## AMENDMENT 2

- 2 BUNGALOW HOMES ADDED
- N. QUEMOY CT. EXTENDED NORTH
- BUFFER LANDSCAPE ALONG PICADILLY PHASED

GREEN VALLEY RANCH EAST  
PRELIMINARY SITE PLAN #5  
TITLE: KEYMAP  
DATE: March 8, 2023

GREEN VALLEY RANCH EAST  
PRELIMINARY SITE PLAN #5  
TITLE: FRONT YARD IRRIGATION AND LANDSCAPE DESIGN  
DATE: FEBRUARY 28, 2023

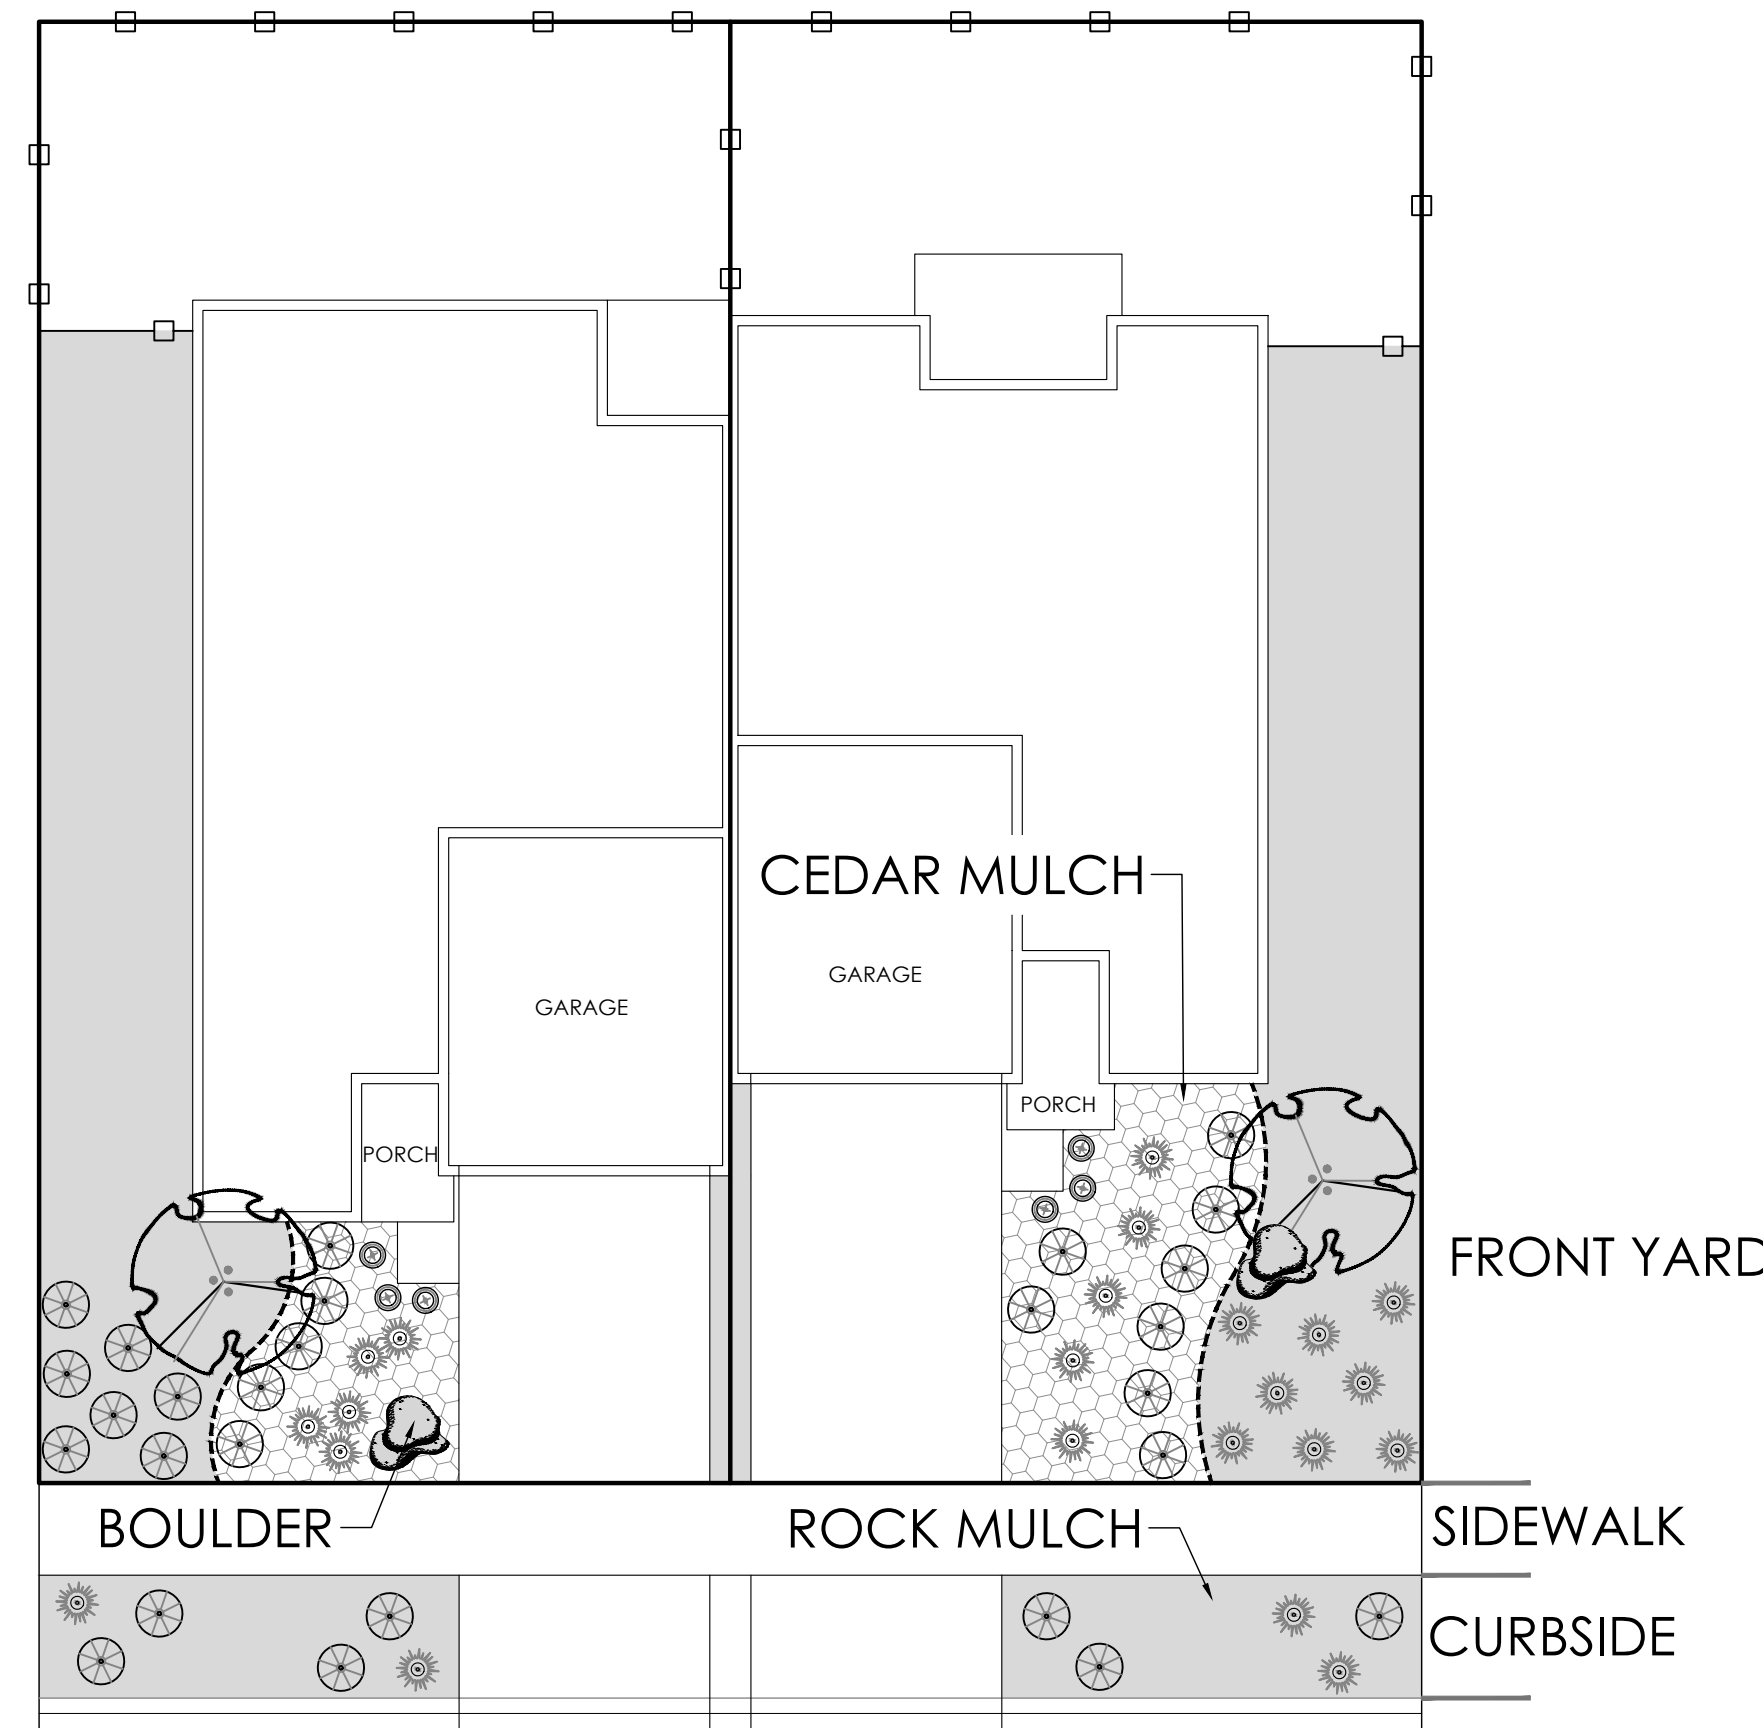
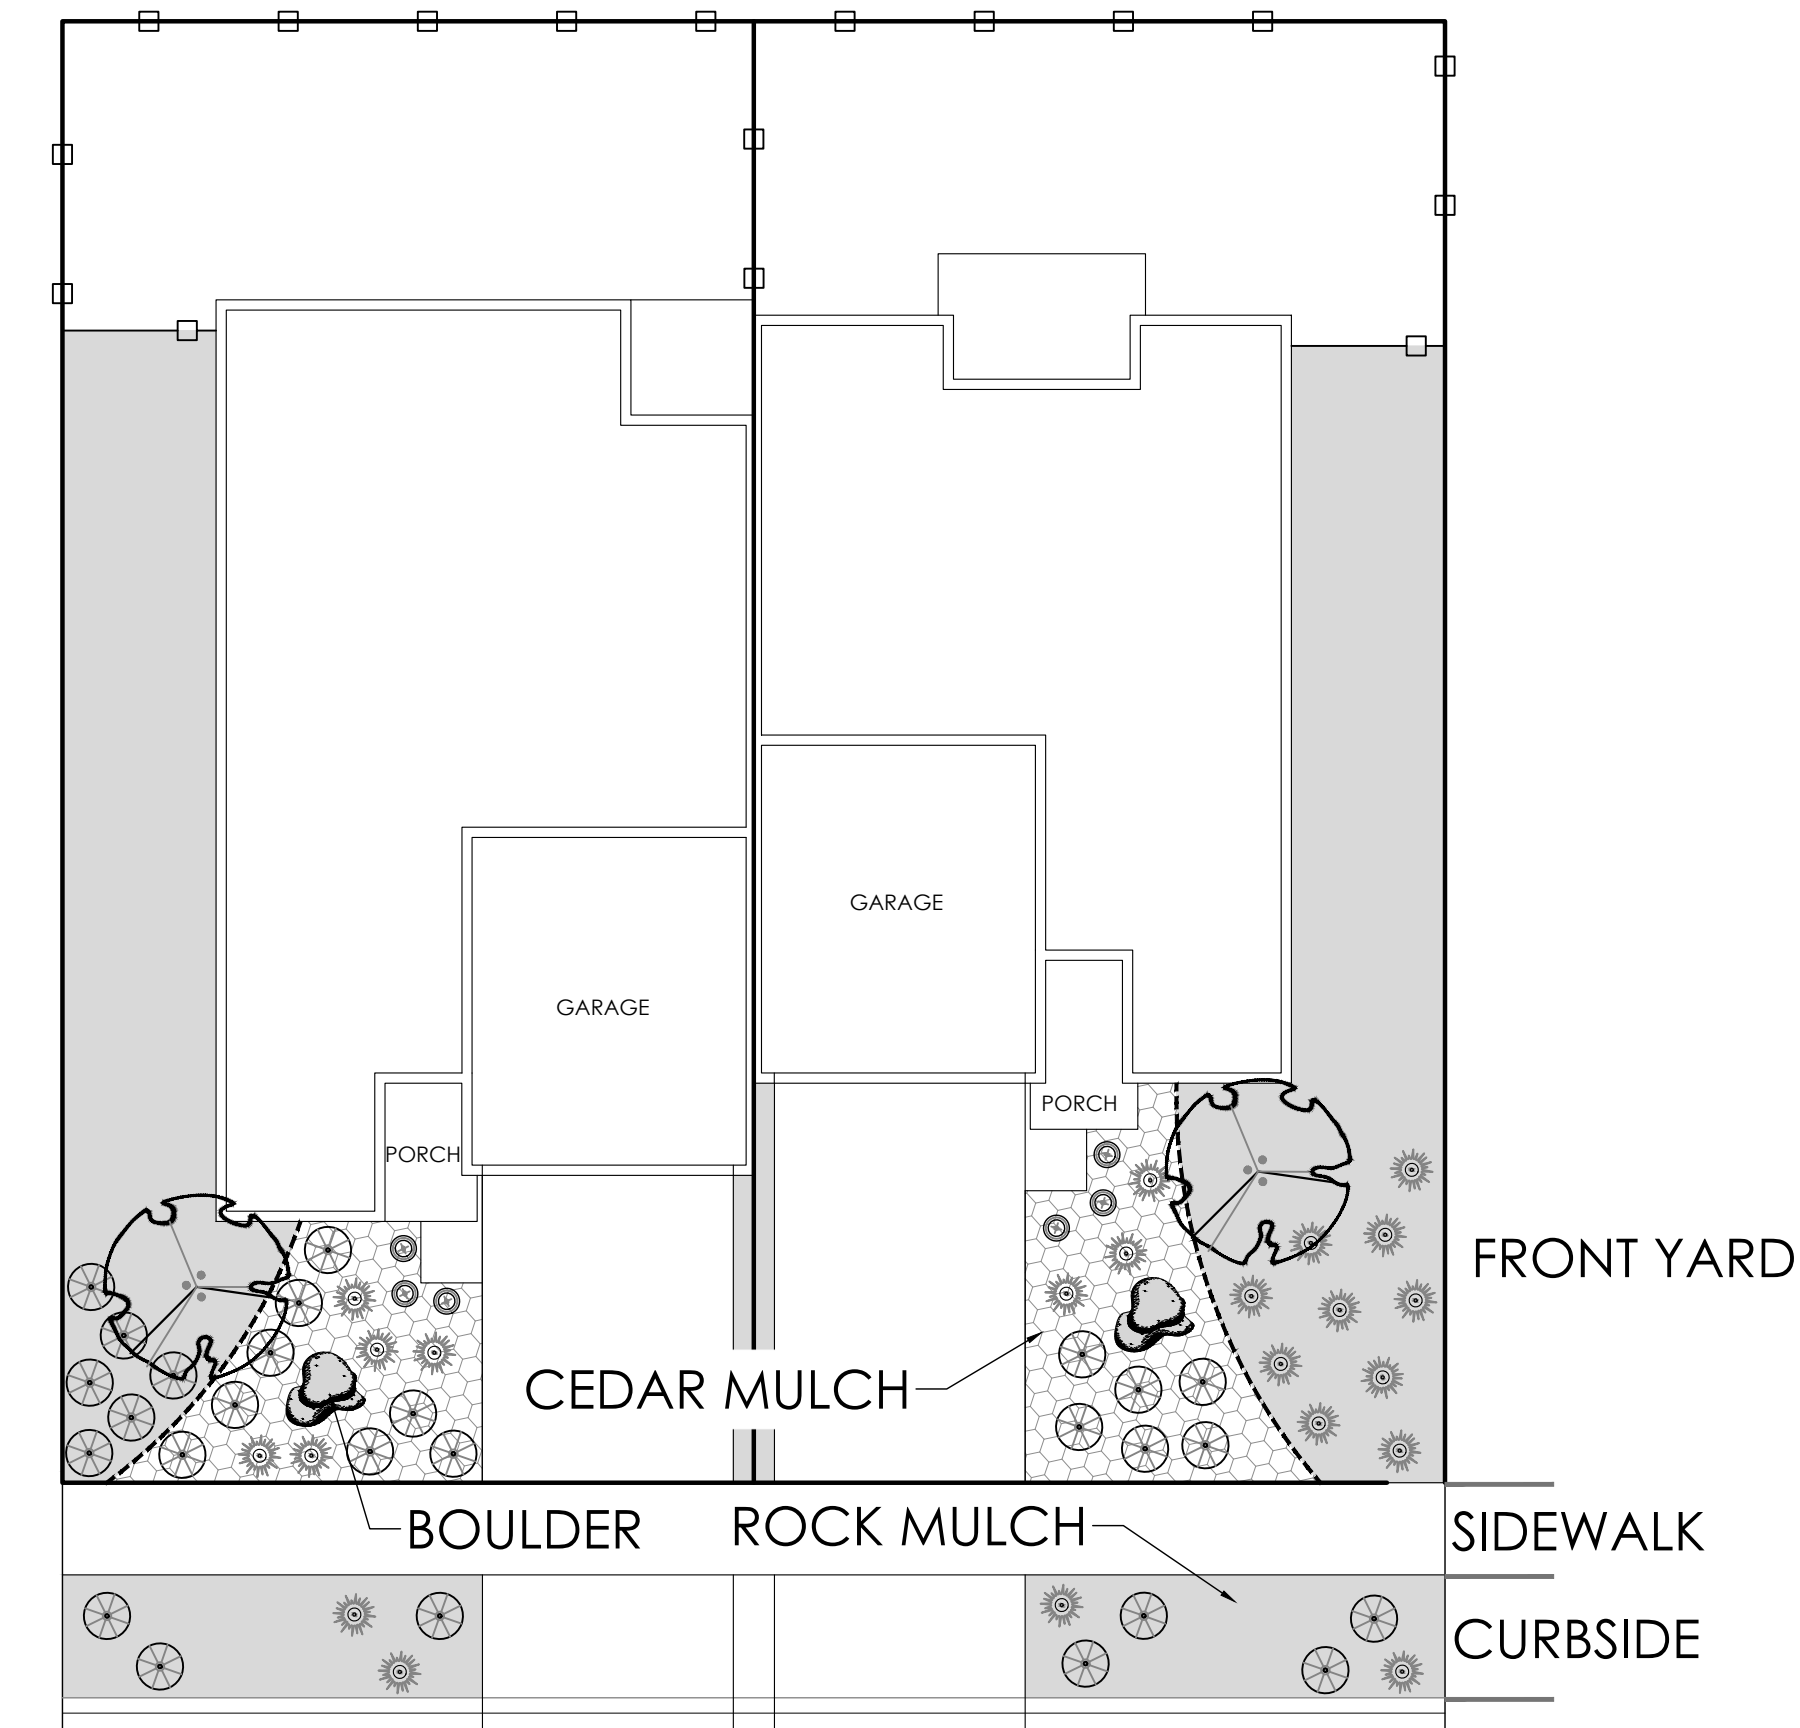
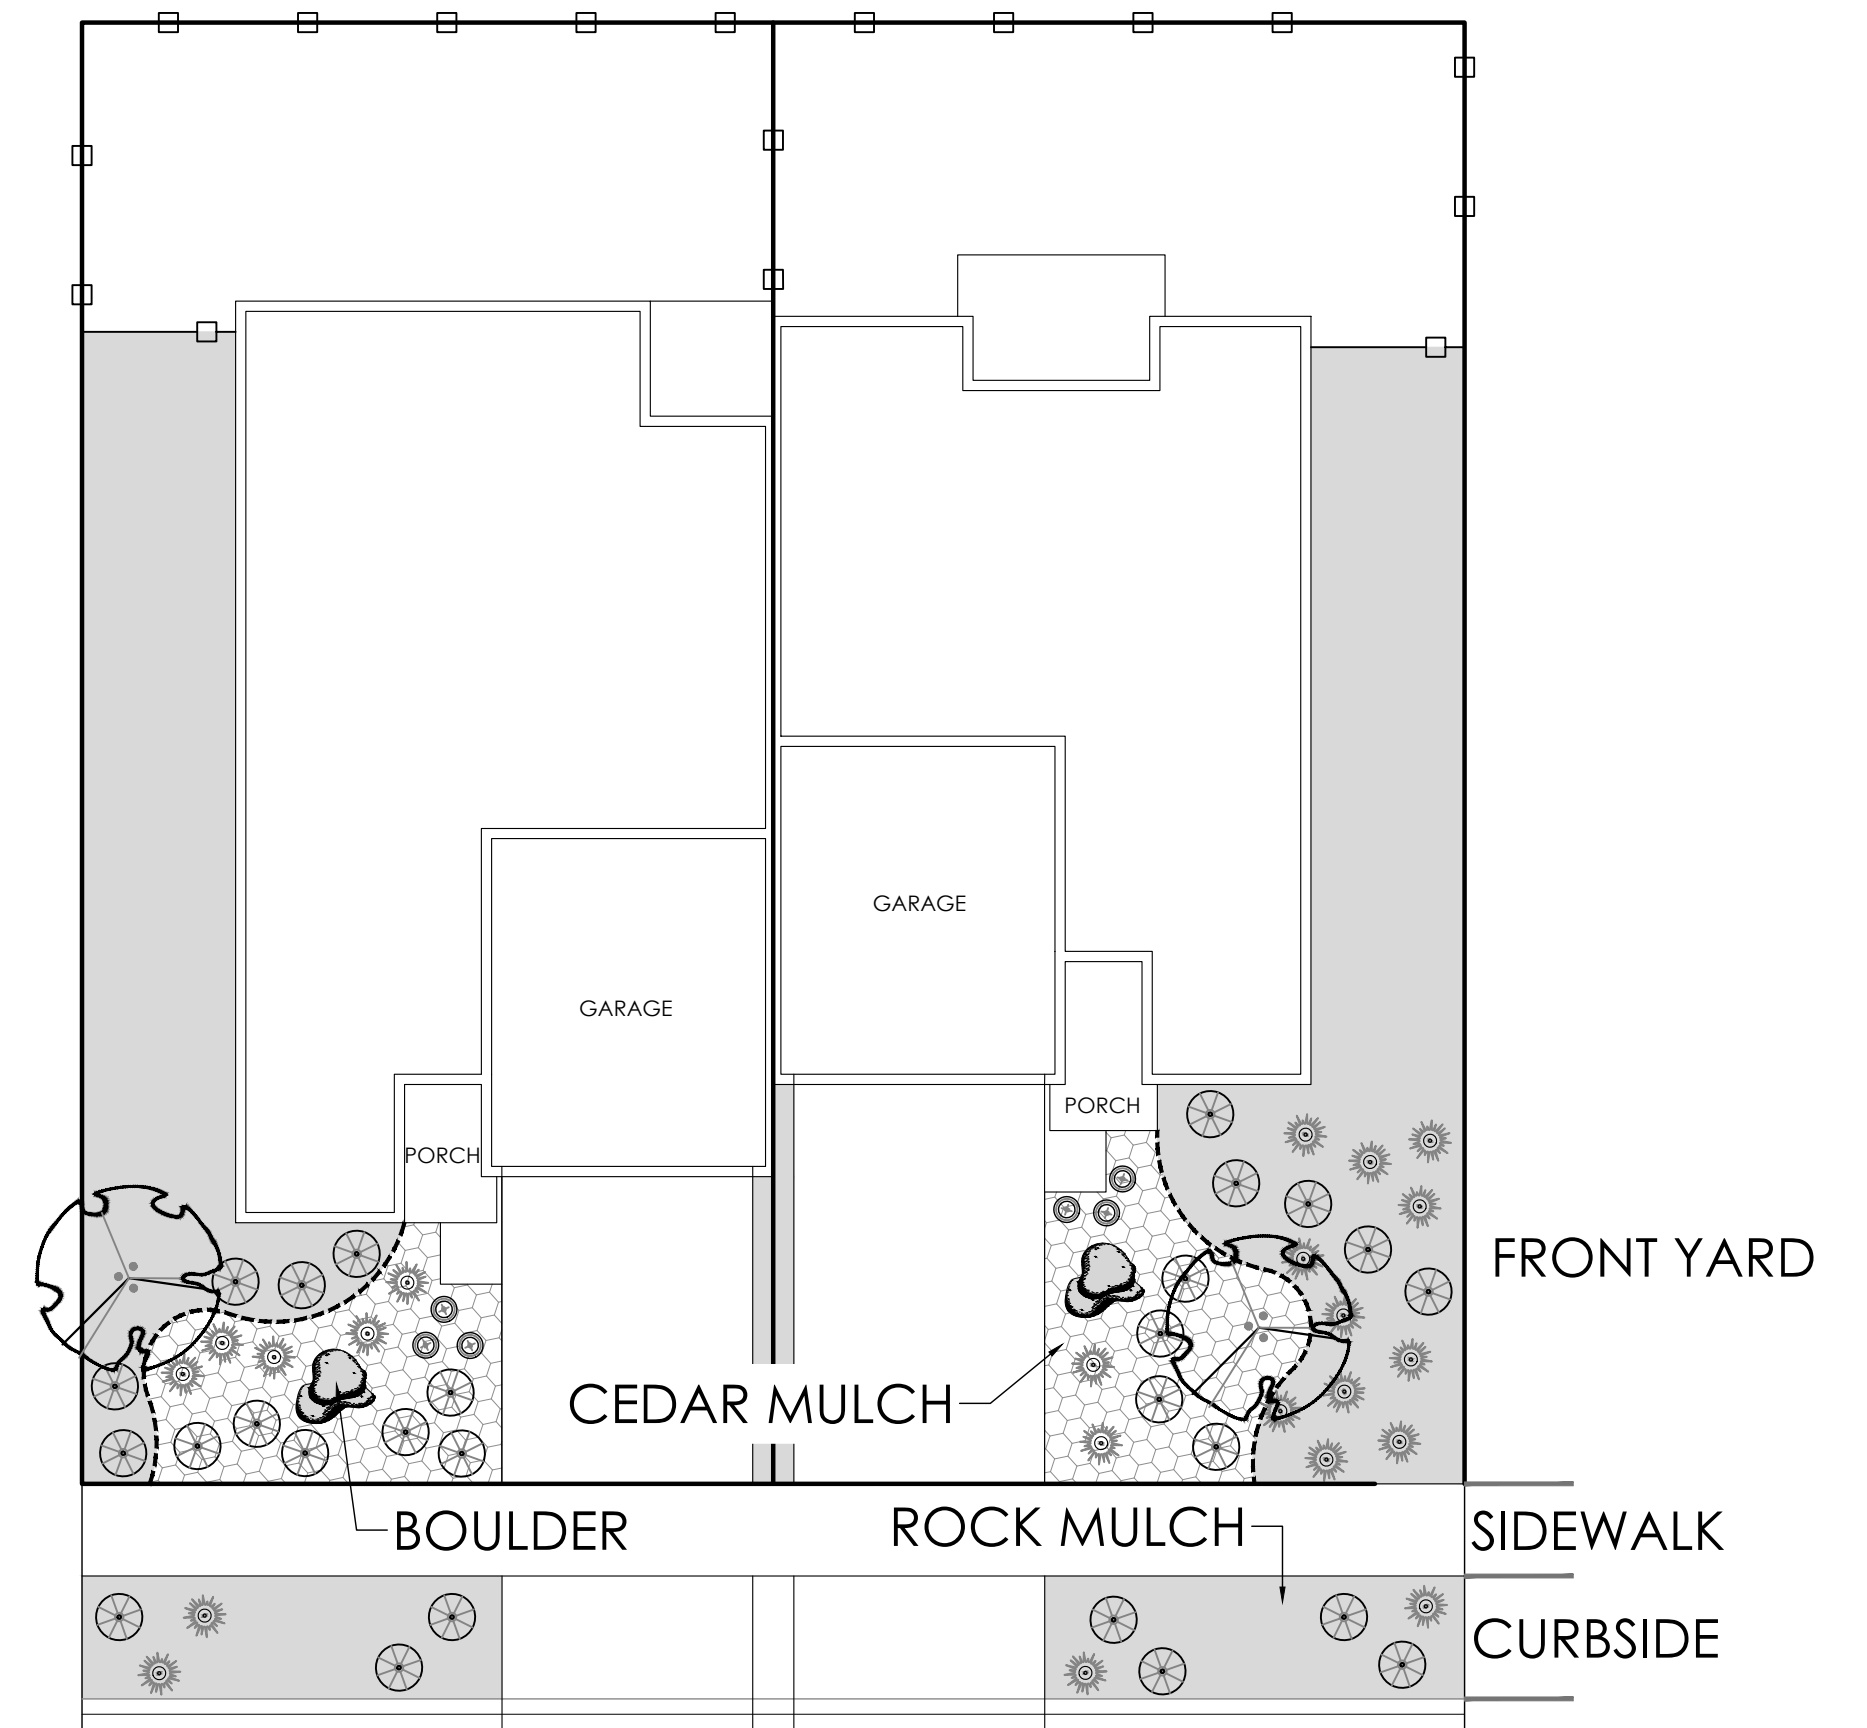
**AMENDMENT 3**  
22 LOTS CHANGED FROM SINGLE FAMILY DETACHED HOMES TO TWO-FAMILY ATTACHED HOMES (DUPLEX). NO CHANGE IN UNIT QUANTITY
